STORM WATER REPORT

Cobey Creek
Mixed Use Development
Lee's Summit, MO

1. Original Storm Report-May 22, 2018
2. Addendum 1- July 1, 2019- Effective Height and Energy Dissipation additions to North Pond
3. Addendum 2- August 3, 2020- Updated South Pond Outlet Structure-Pond Pack Print out.
4. Addendum 3- October 8, 2020- Approved Outlet Structure Geometric Changes from Circular to Square and Rectangular

Addendum 3
Cobey Creek
Mixed Use Development
Lee's Summit, MO

ISOMETRIC VIEW

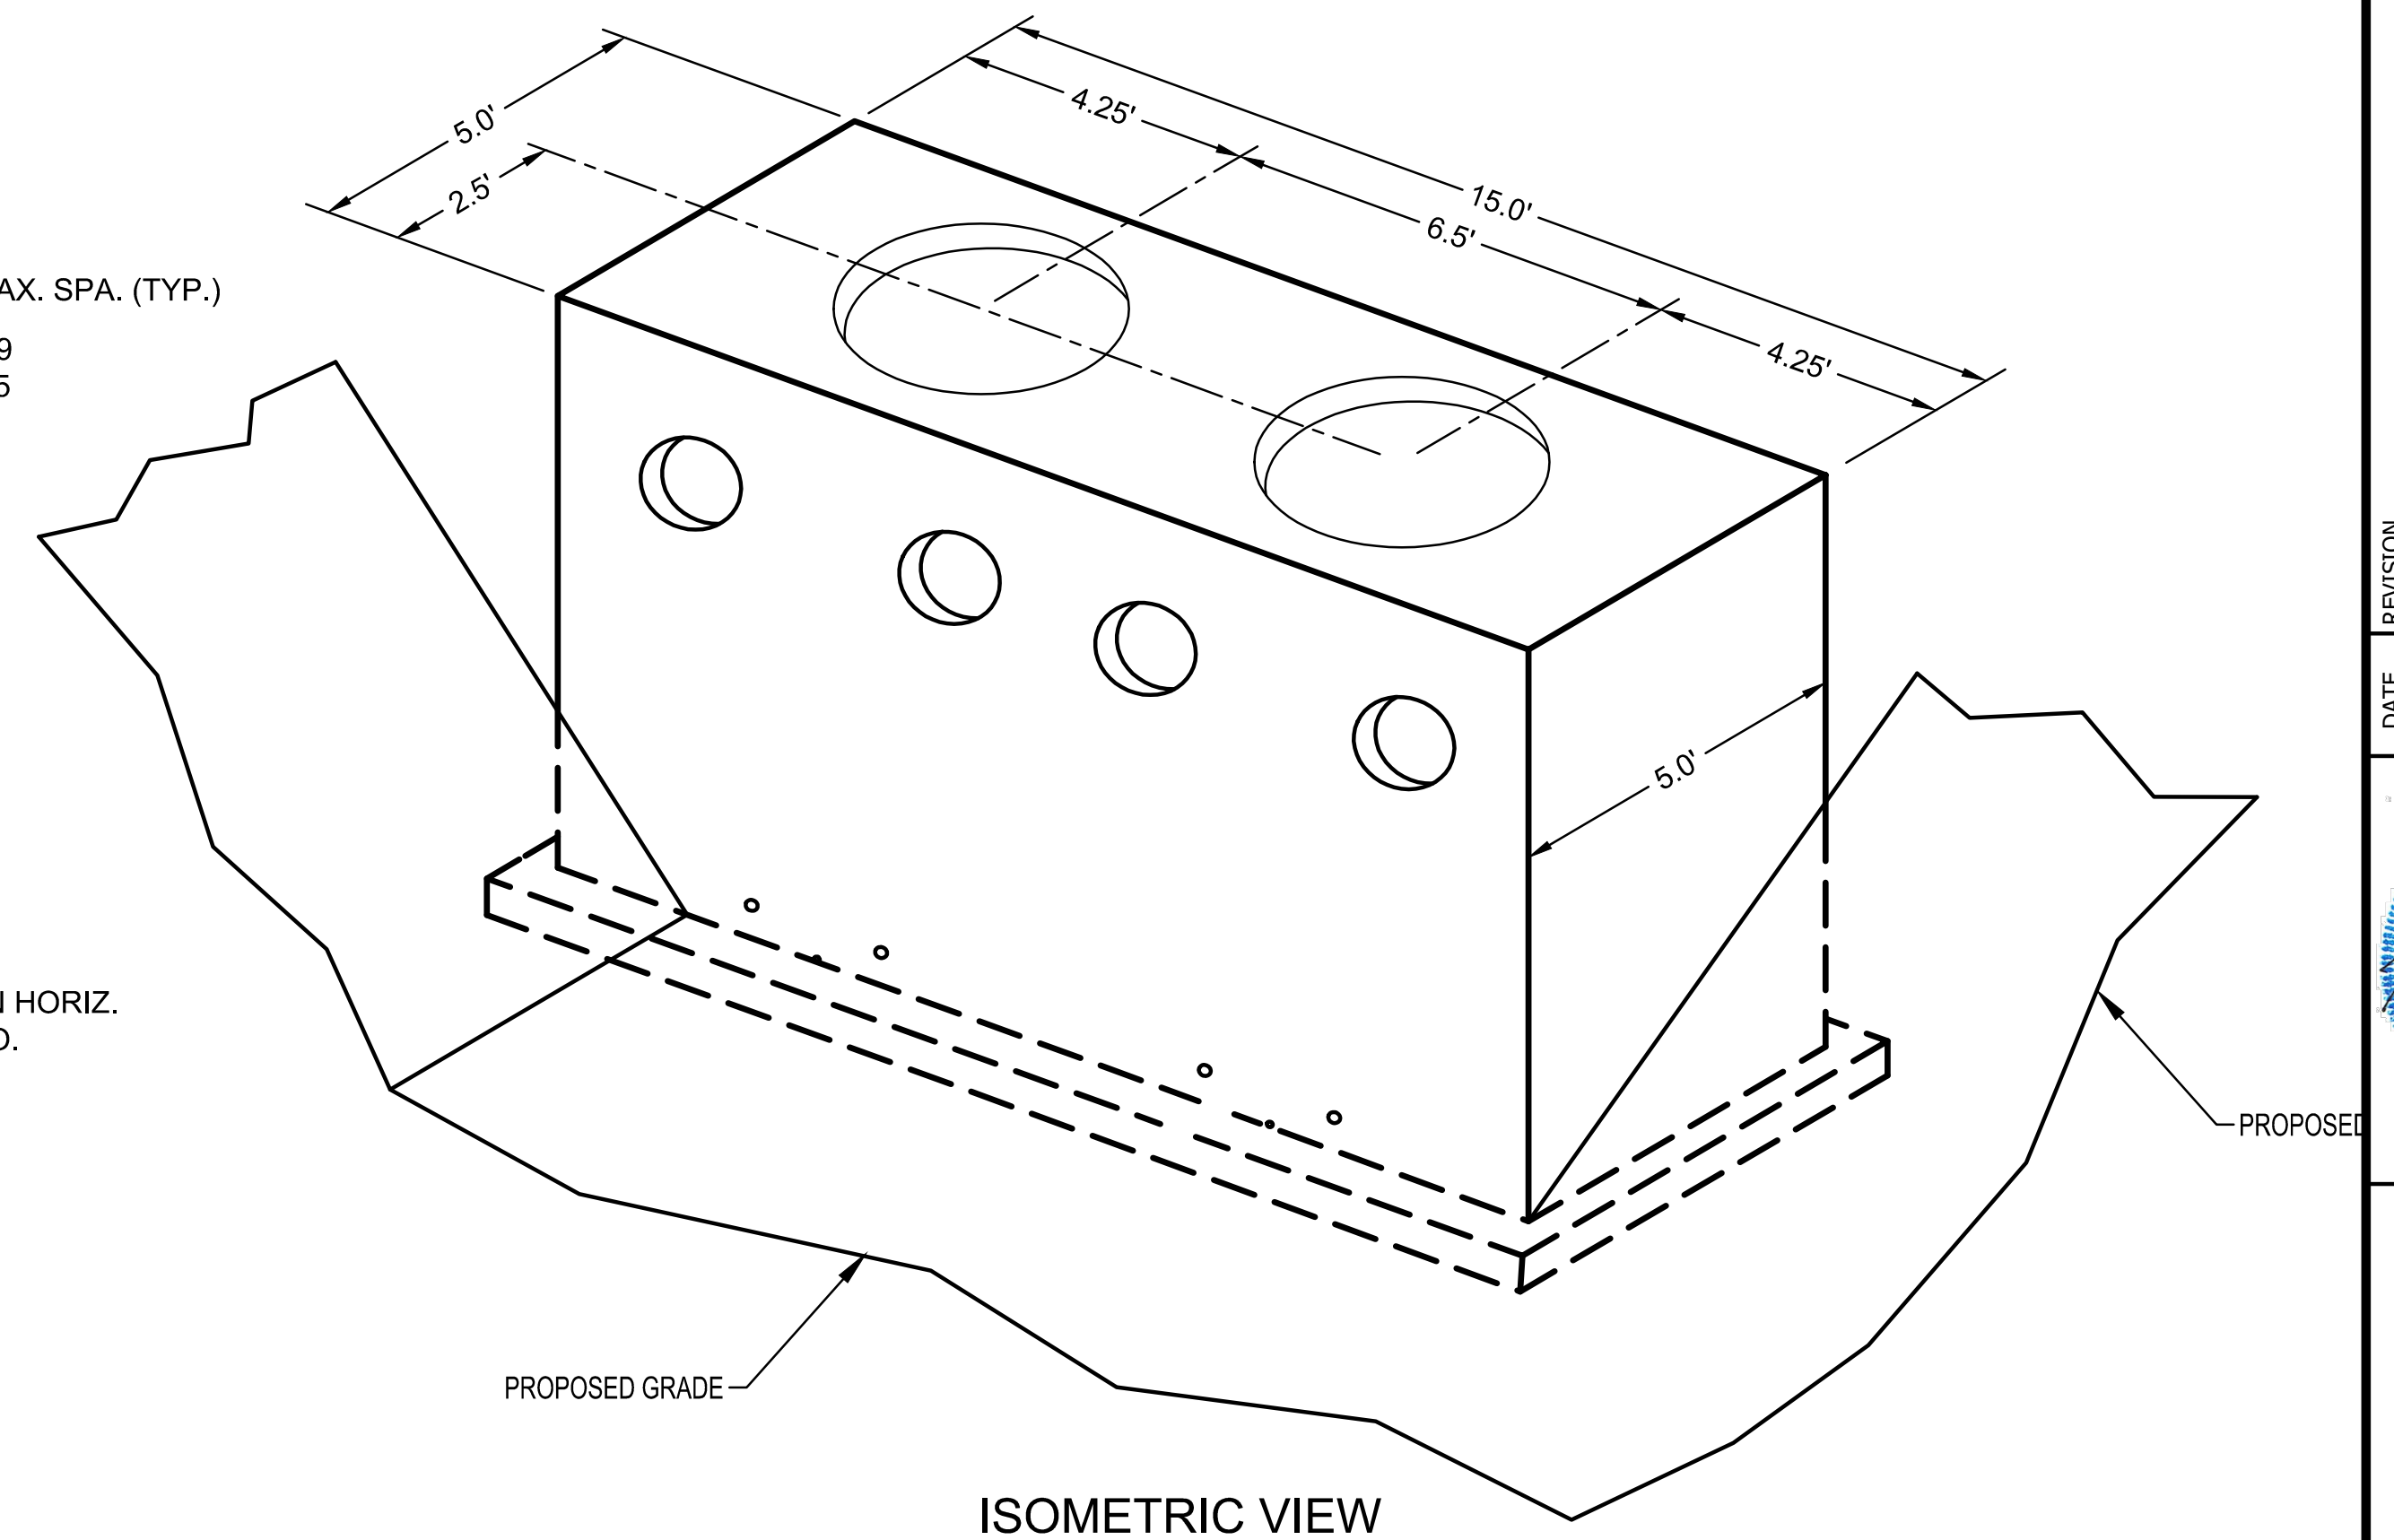
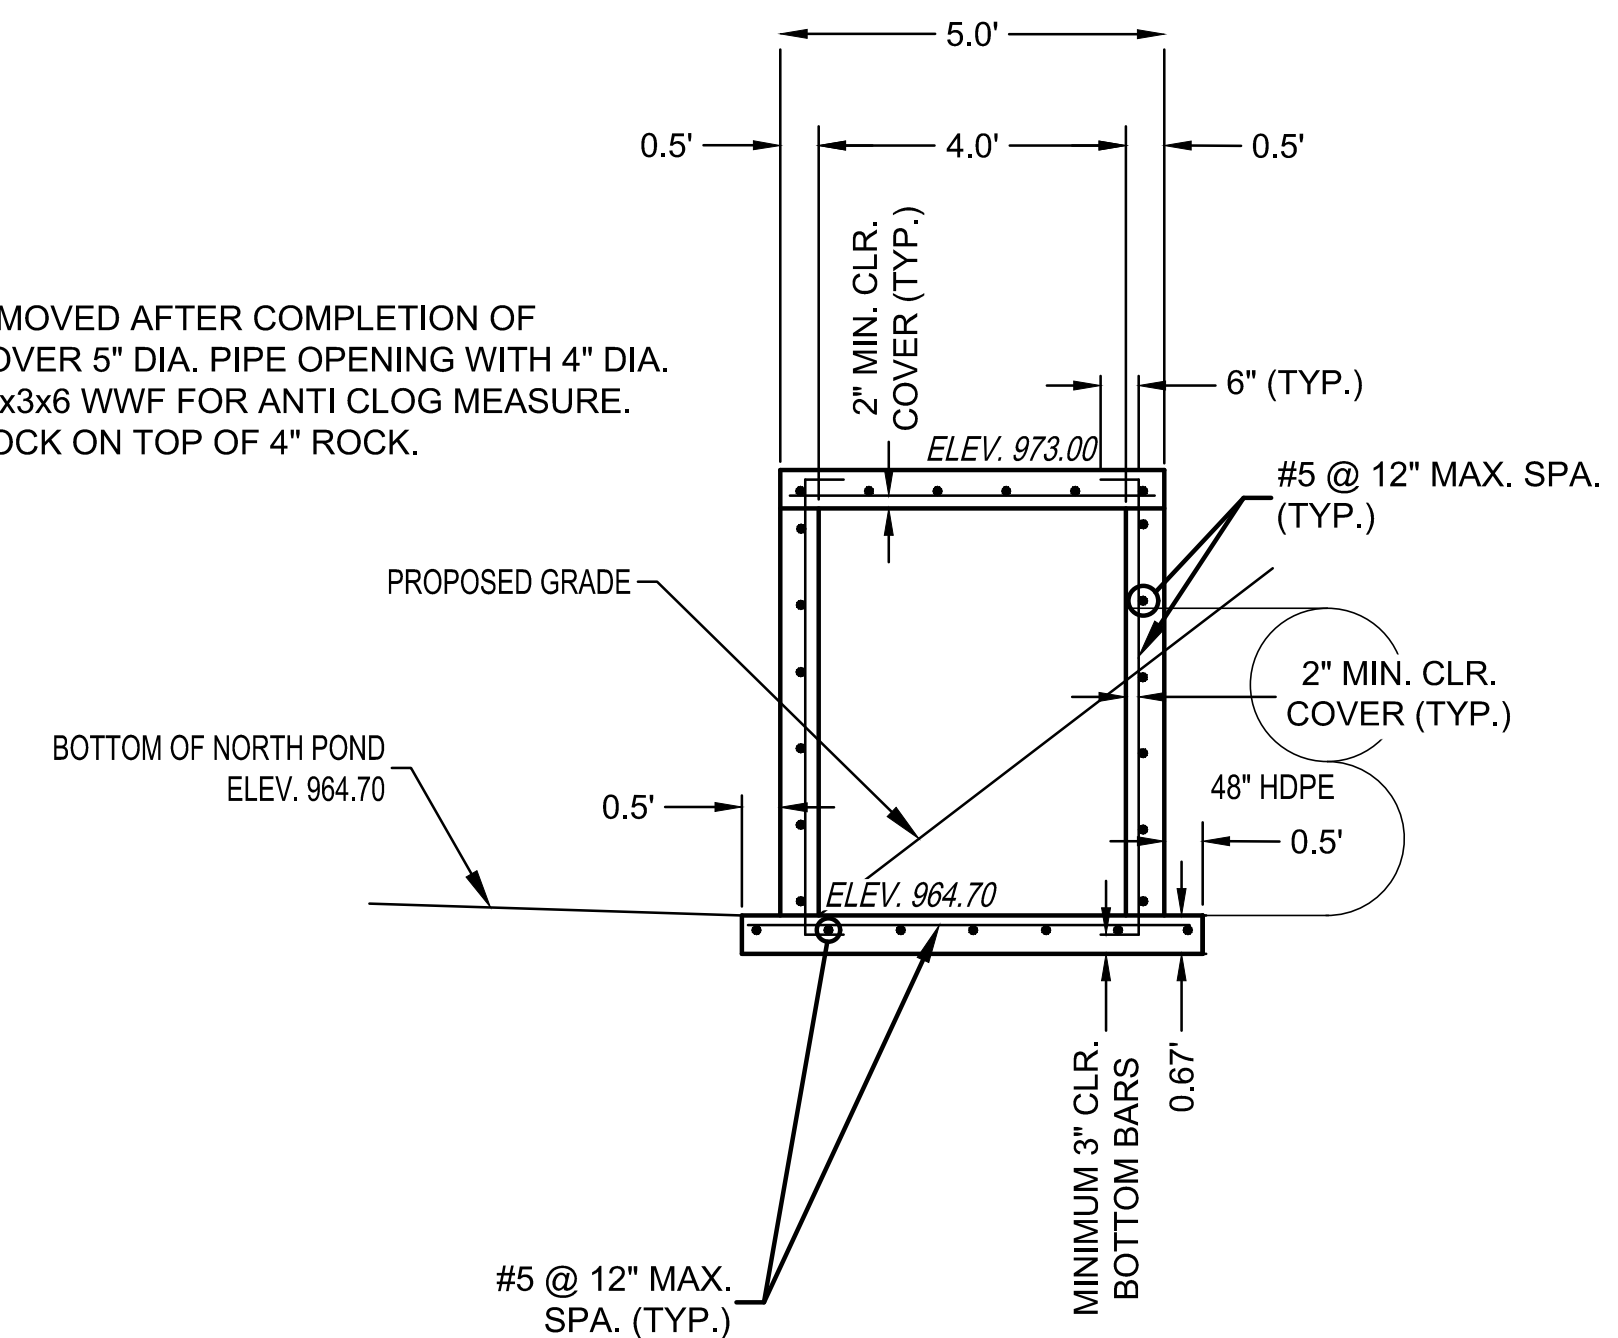
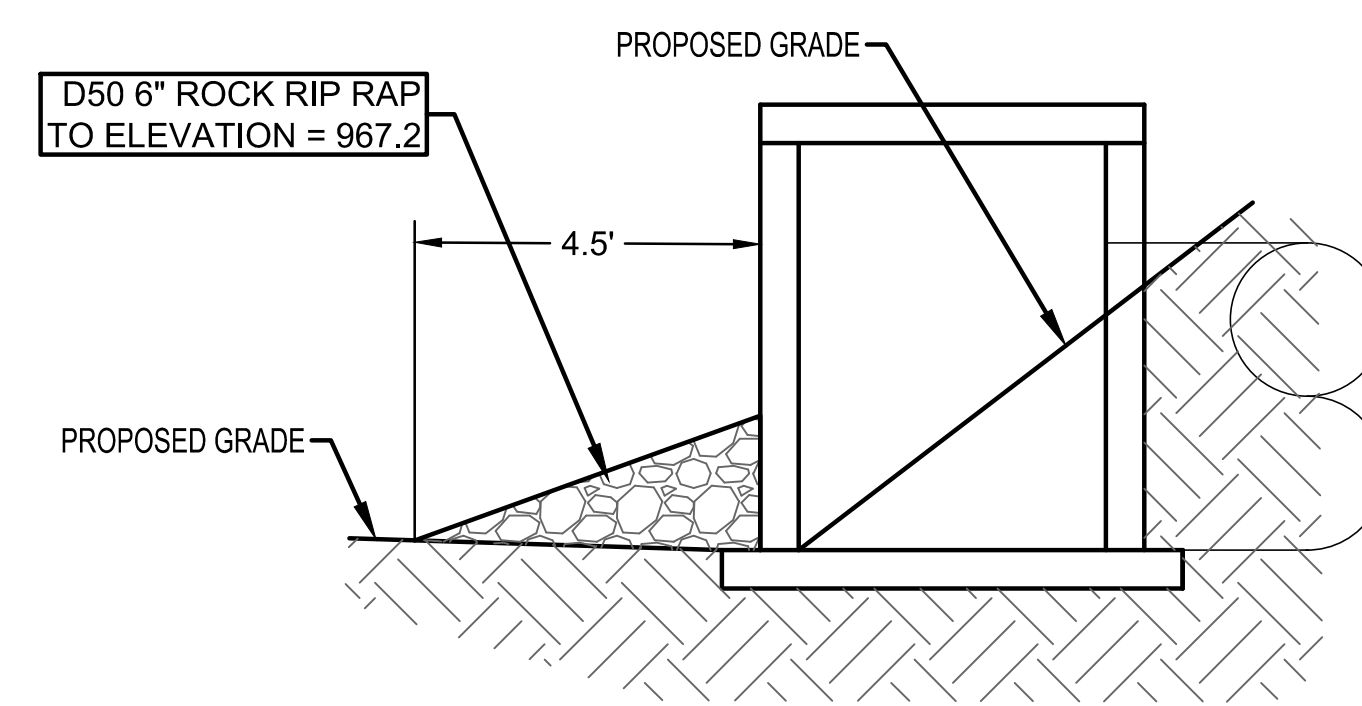
This addendum to the Final Storm Report for Cobey Creek, Phase 1 is prepared for addressing the change to the geometric shape of the outlet structure in the north pond from circular to rectangular, due to the unavailability of a six foot diameter manhole.

This change is the same as the change at the south pond, except that the north pond design called for 2 circular manholes side by side. The shape of the outlet structure has been redesigned to incorporate the 2 manholes into one larger and rectangular structure. All orifices that were shown for the manholes have been incorporated into the rectangular structure at the same elevations to provide the same hydraulic flows at the various storm events as originally designed. Details of the new and approved structure are attached.

The approved outlet structure in the north detention pond is 2- 6' diameter manholes with the accompanying orifice openings and pipe sizes and locations shown. Due to the inability of the local precasters to provide a manhole of the diameter required, an alternate shape of structure is needed.

It is proposed that in lieu of the 2- 6 diameter manholes, a single 5' x 14' rectangular concrete box be used, to provide the same function.

As detailed, the rectangular concrete box will provide the same orifice opening sizes, elevations and domed grates as the approved manholes, with no changes in the hydraulic function of the structure or pond from the approved version of the plans and storm report.

Upon approval, the contractor intends to cast the box in place per the detail and in the location shown on the detention plan.
